Director
Infrastructure Projects Planning Services
Department of Planning and Environment
Application number SSI 6307
GPO Box 39
SYDNEY NSW 2001

RE: PARRAMATTA ROAD INTERCHANGE HABERFIELD/ASHFIELD.

Figure 1: Parramatta Road Interchange.

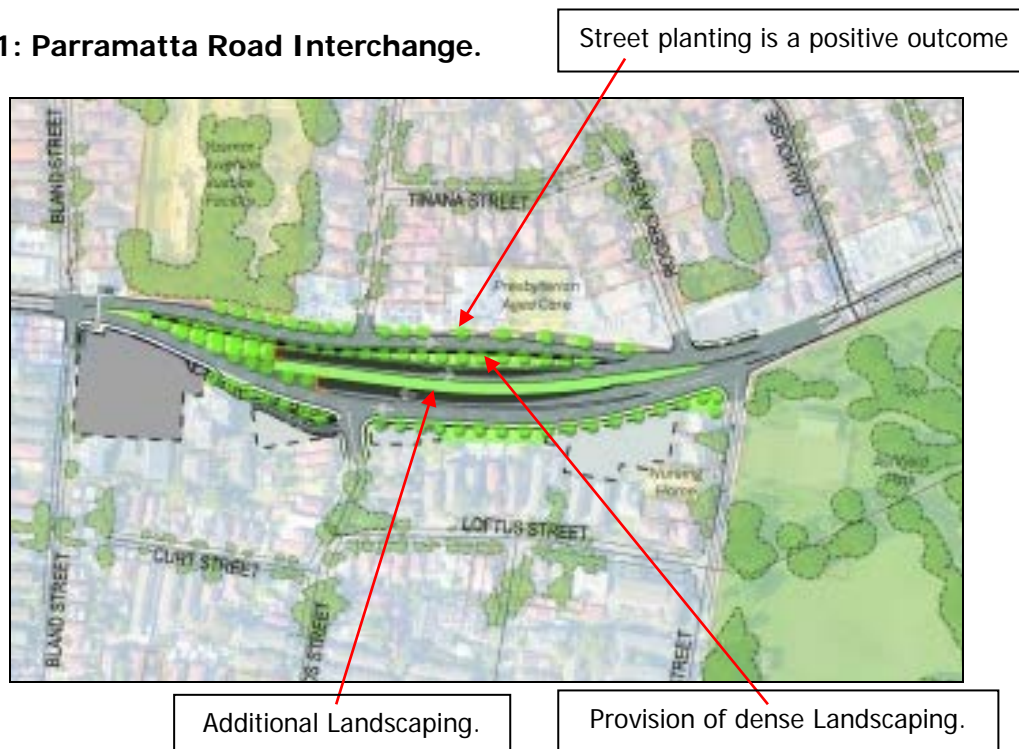
We also note, and reproduce in Figure 1 below, that there is dense landscaping as indicated in the images attached as Figure 2 and 3, being the artist's impression of this interchange. This landscaping should be provided to create a visual buffer between the M4 Interchange and surrounding residential properties and should be of a substantial size and quality.

Figure 4: Sensitive Uses.

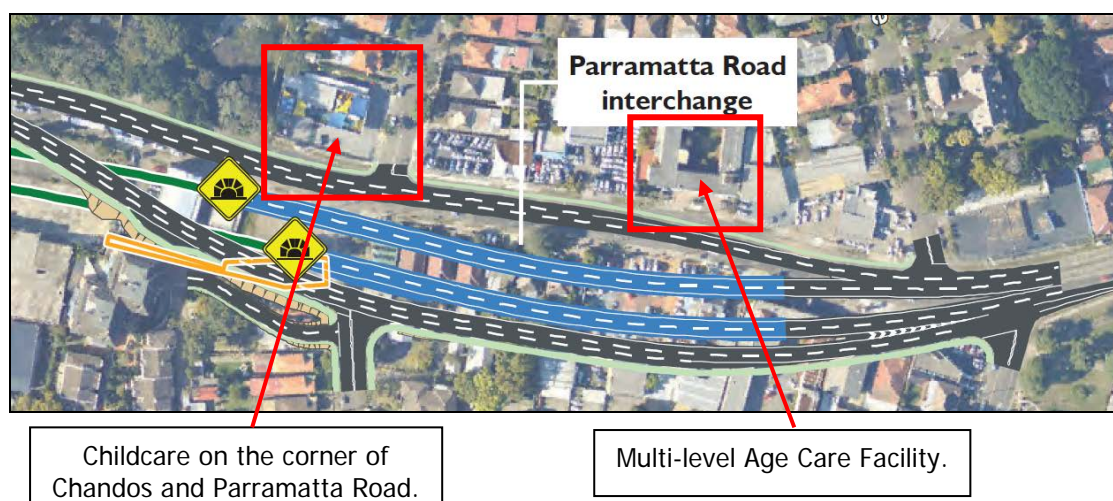
In addition to our current interface, it is also noted that there are other sensitive uses in our immediate area facing Parramatta Road. Figure 4 illustrates such examples being the

childcare centre on the corner of Chandos Street and Parramatta Road and the aged care facility located mid-block between Chandos Street and Rogers Avenue. If one refers to the New Parramatta Road Strategy, there is an acknowledgement that there needs to be at least a 20 metre buffer to sensitive uses such as senior housing development and other types of residential accommodation. For child care centres, a buffer on either side of the road should be 80 metres.

Figure 5: Noise Walls.

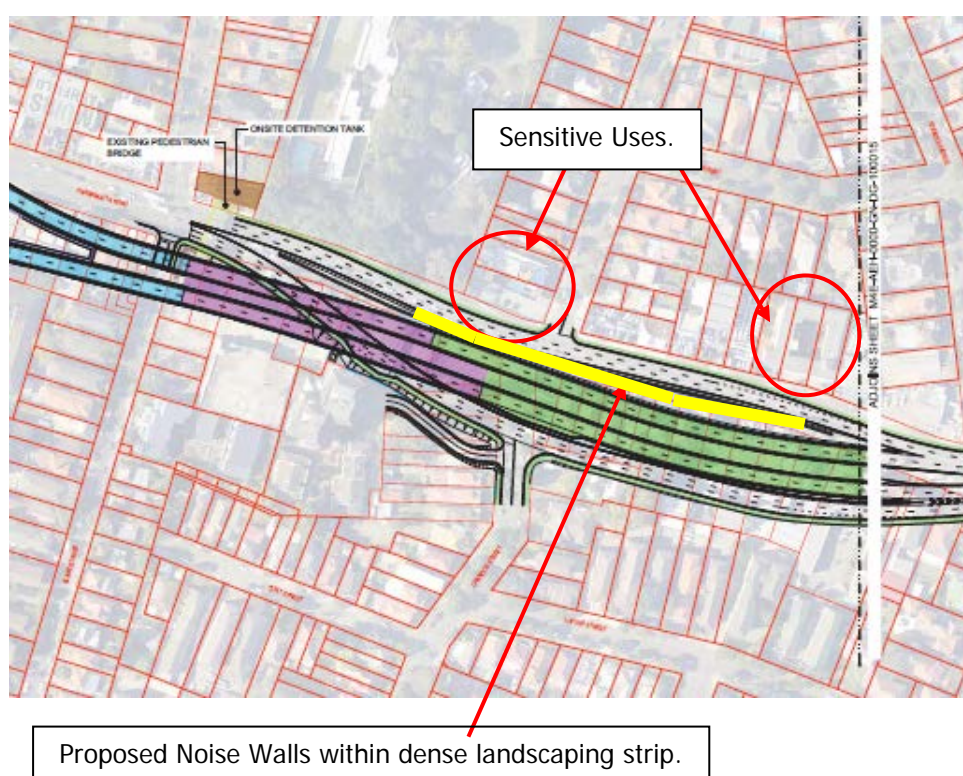
Clearly, this is not possible and it is therefore our submission to maintain consistency, from a strategy perspective, that noise barriers between the three lanes located on the northern side of Parramatta Road and the exit tunnel heading towards the city be erected. Figure 5 illustrates the area in which the acoustic wall should be erected.

Figure 6: Proposed cul-de-sacs.

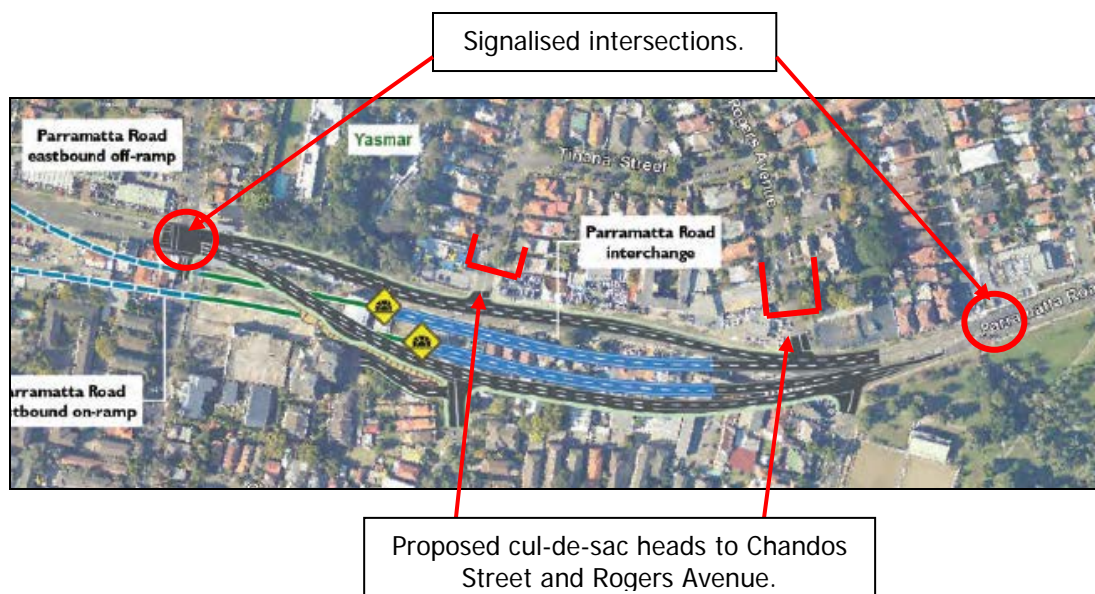
It is our submission that consideration should be given to the provision of a cul-de-sac at the end of Chandos Street and to Rogers Avenue. Figure 6 is an illustration prepared by myself to reinforce and illustrate the location of such cul-de-sacs.

Figure 7: Traffic Flow.

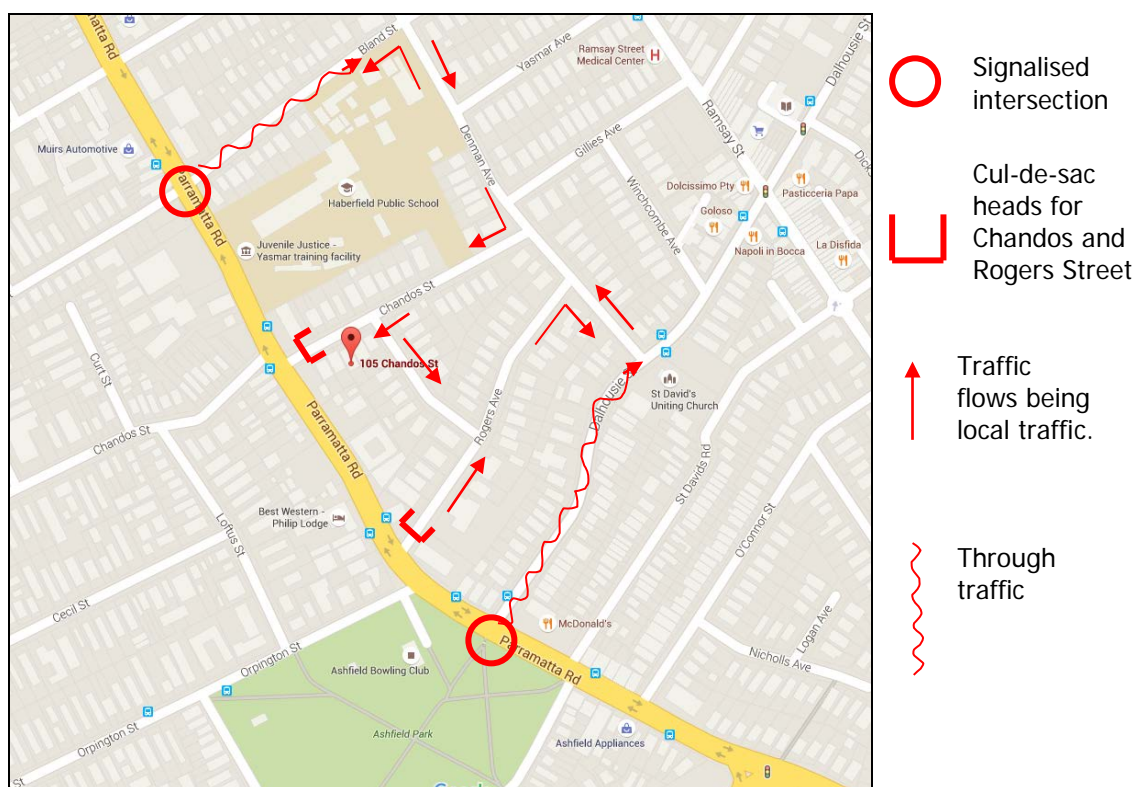
The importance of these cul-de-sacs ensures that commercial properties along Parramatta Road can still maintain access and can do so in a safe and appropriate manner. Evident in Figure 7, Rogers Avenue and Chandos Street are local streets servicing only a handful of properties. It is clearly evident as illustrated in Figure 7 that through traffic should not be encouraged through local streets. RMS would acknowledge, and reinforced under the Infrastructure SEPP, that access to classified roads is not encouraged. The suggested change ensures that traffic which moves along Parramatta Road enters and leaves Parramatta Road through signalised intersections which will assist in the flow of traffic.
